GROUP	MODEL
ELE	2025MY EV6 (CVa)
NUMBER	DATE
410	January 2026

TECHNICAL SERVICE BULLETIN

3 WAY VALVE REPLACEMENT (CA2513)

3 WAY VALVE REPLACEMENT (CA2513)**Repair Procedure 2WD:**

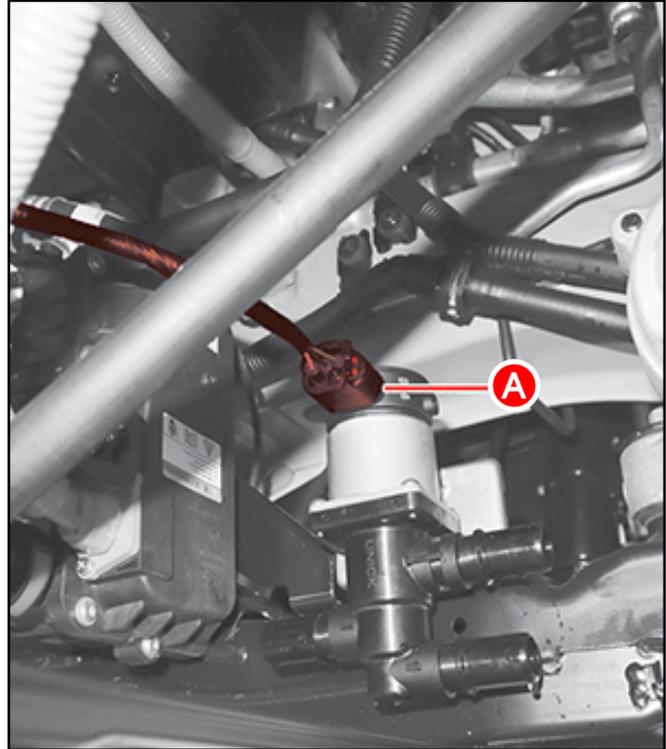
1. Replace the 3 Way Valve by referring to "EV6(CV1A) → 2025 → 160kW (2WD) / 70kW 160kW (AWD) → Cooling System → High Voltage Battery Cooling System → 3 Way Valve → Removal and Installation → 2WD" in the applicable Shop Manual on KGIS.

**Repair Procedure AWD:**

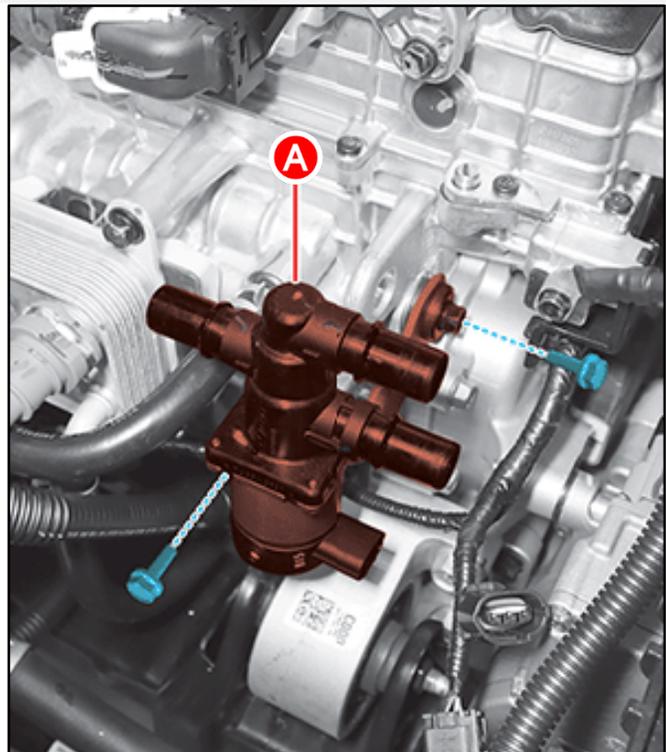
2. Replace the 3 Way Valve (A) by referring to "EV6(CV1A) → 2025 → 160kW (2WD) / 70kW 160kW (AWD) → Cooling System → High Voltage Battery Cooling System → 3 Way Valve → Removal and Installation → 4WD" in the applicable Shop Manual on KGIS.
